SB: **Wall mounted hose box rollup 35Li**

Article : 8025

Reason: Modification of the battery

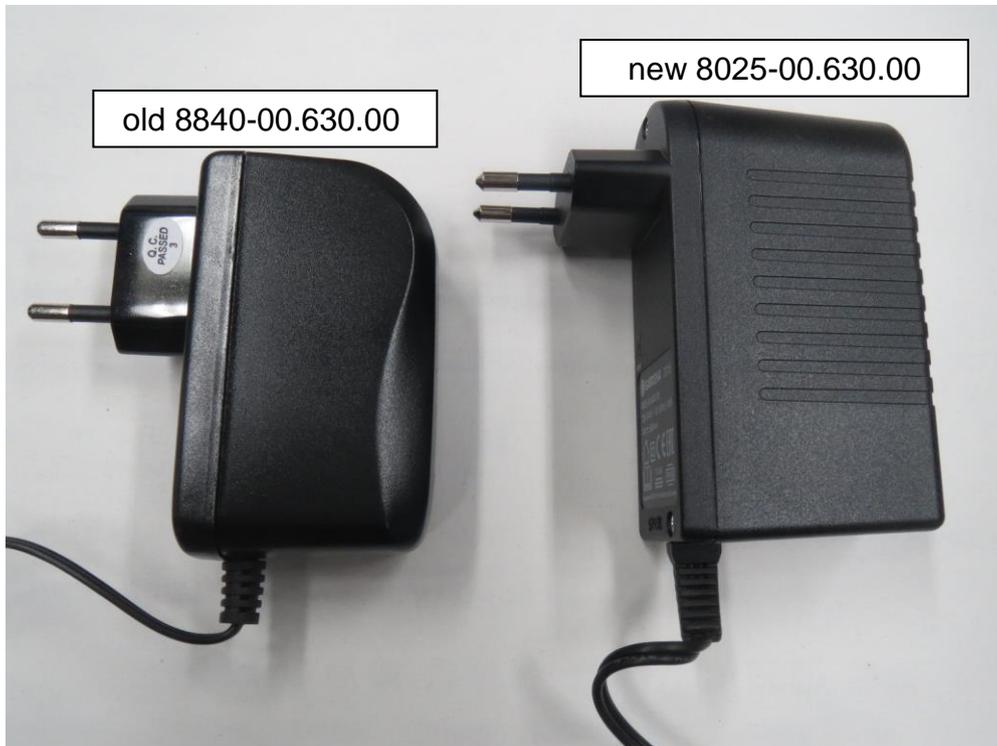
1. With index “E619” (cw 19/2016) a new rubber button and a new designed label have been implemented to improve the resistance against water.

2. With index “J” new battery cells with higher capacity (2,2 Ah instead of 1,6 Ah) will be implemented for 2017. These batteries with higher capacity may only be charged with a new charger (part. no. 8025-00.630.00), don't use the old one with part. no. 8840.00.630.00 !

New spare parts : charger 8025-00.630.00
 battery 18V/ 2,2Ah 8025-00.900.07
